TRANSMISSION SEMINAR 1991

TRANSMISSION SEMINAR

Technical Service Information

Figure 65

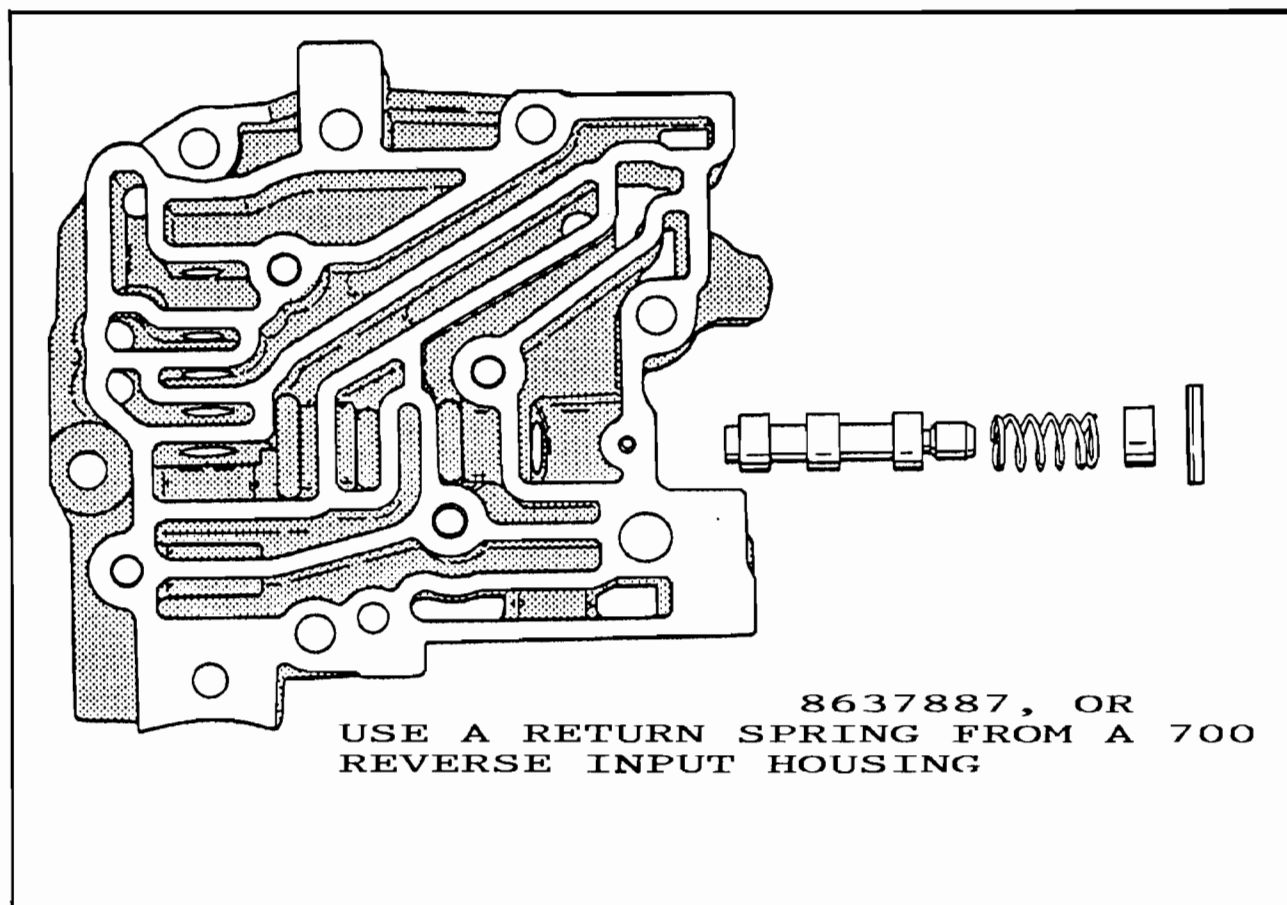
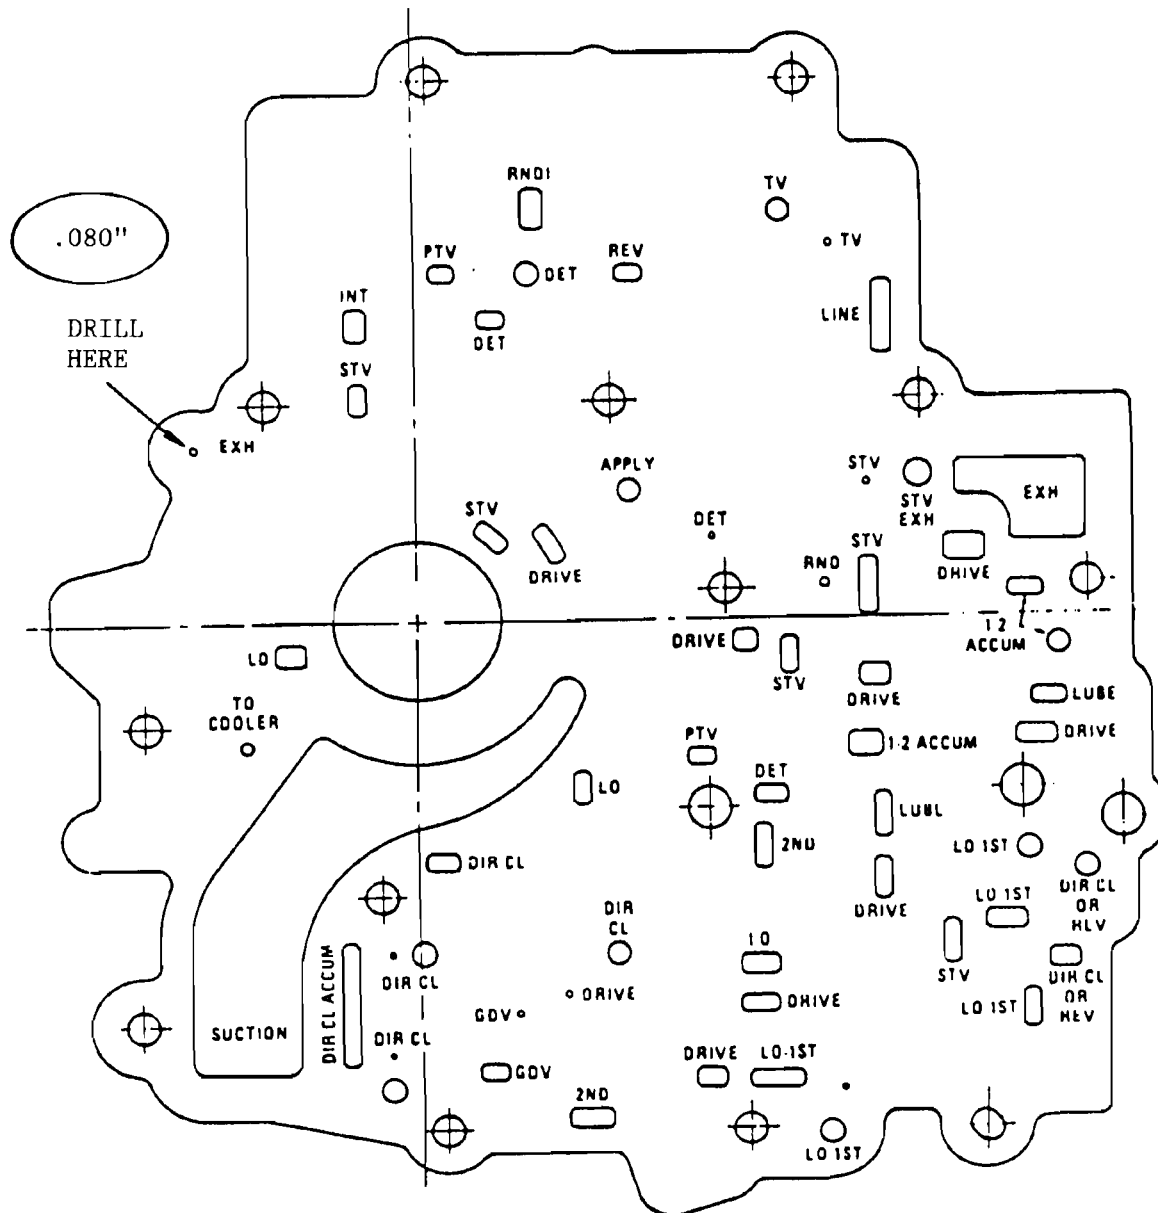
CORRECTION: Install a stronger converter clutch regulator valve spring, OEM part number 8637887, or use a return spring from a 700 reverse input housing return spring assembly. Also drill the converter clutch exhaust hole in the spacer plate to .080". Refer to Figures 65 and 66.

Figure 67

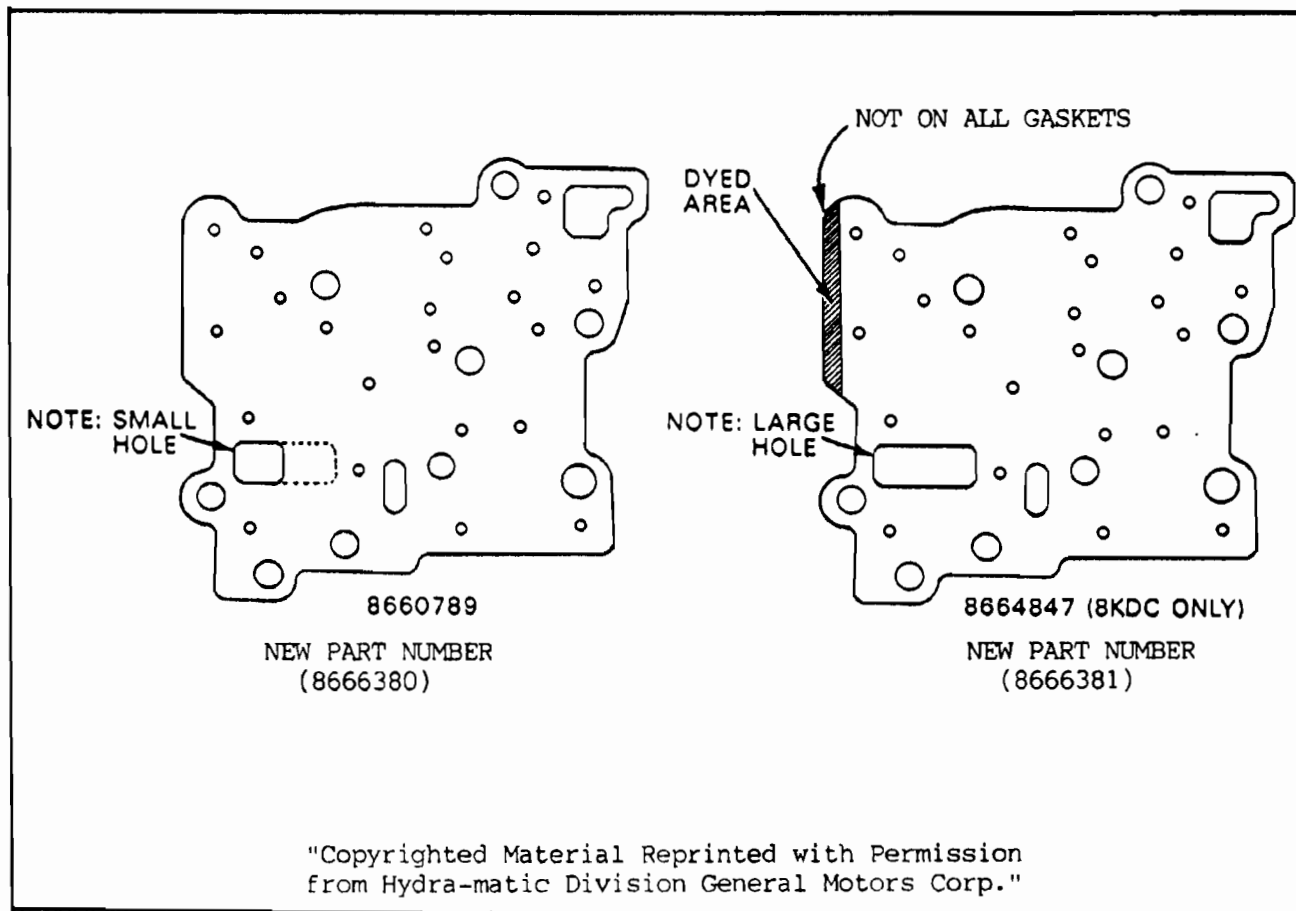
CORRECTION: Install the 1988 (KDC) auxilliary valve body gasket with the
large hole (See Figure 67, or modify the 1987 gasket with the
small hole, by cutting on the dotted line (See Figure 67).

Figure 74

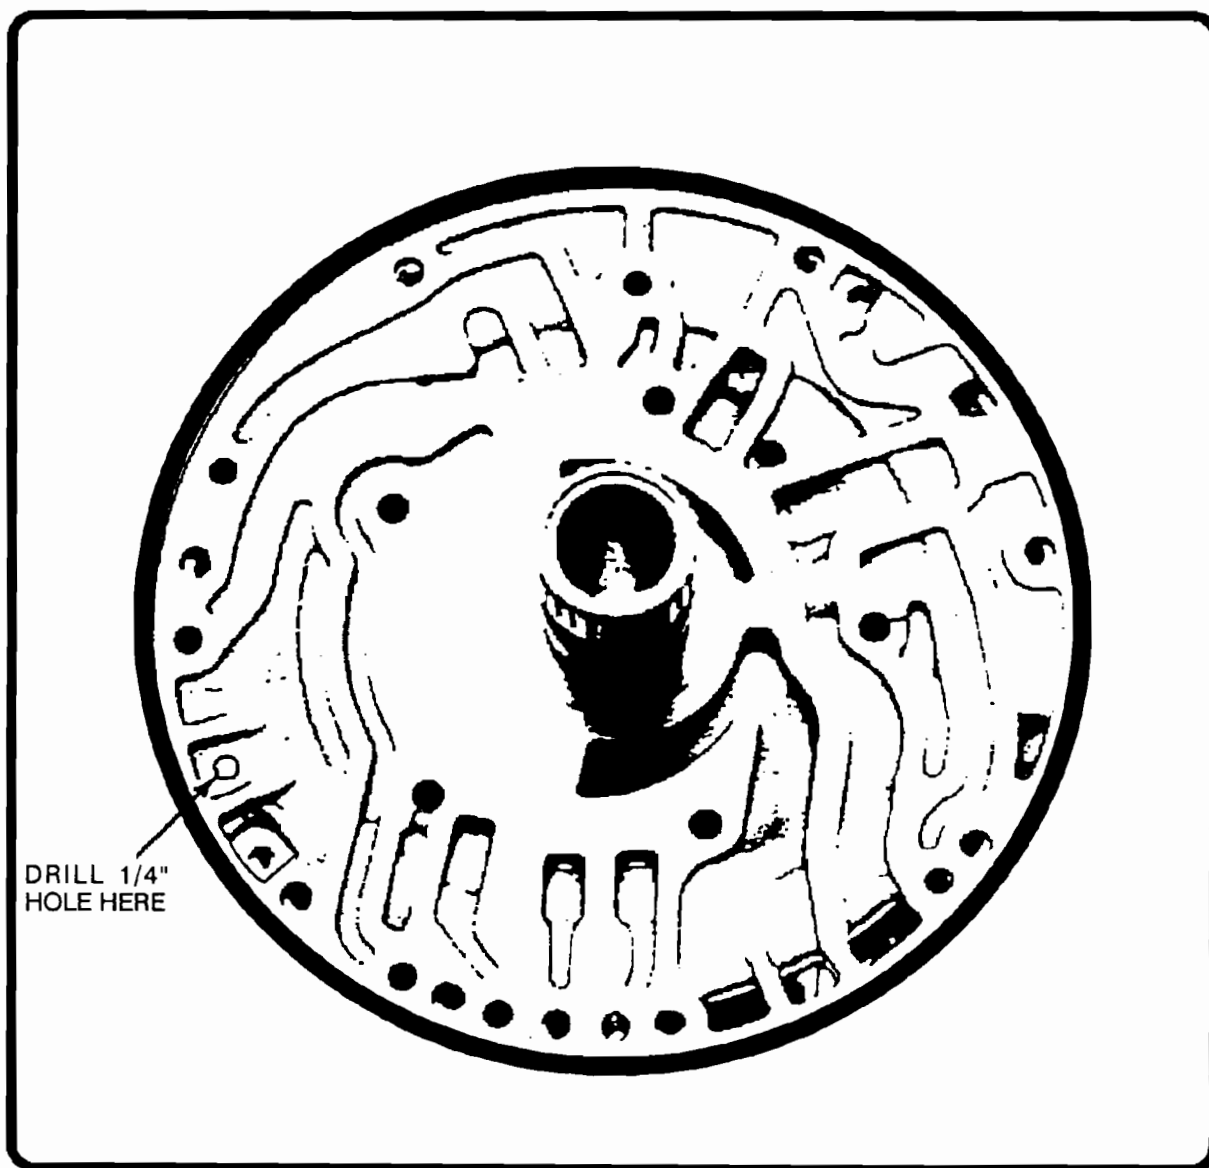
- (1) INSTALL COMPLETE NON LOCK-UP PUMP.
DO NOT INTER-MIX PUMP HALVES.
- (2) DRILL 1/4" HOLE IN DRAINBACK AREA,
AS SHOWN IN FIGURE 74.
- (3) INSTALL ORIGINAL LOCK-UP VALVE BODY
AND SPACER PLATE.
- (4) REMOVE ROLL PIN AND BORE PLUG AND
SPRING FROM AUXILIARY VALVE BODY,
AS SHOWN IN FIGURE 73.
- (5) INSTALL PIECE OF RUBBER HOSE IN
PLACE OF SPRING AND INSTALL BORE
PLUG AND PIN. SEE FIGURE 73.
- (6) INSTALL NON LOCK-UP CONVERTER.
- (7) MAKE A SOLID GASKET AND INSTALL
UNDER THE SOLENOID.
- (8) LEAVE THE NUMBER 5 CHECKBALL OUT
OF THE CASE (FRONT OF CASE).
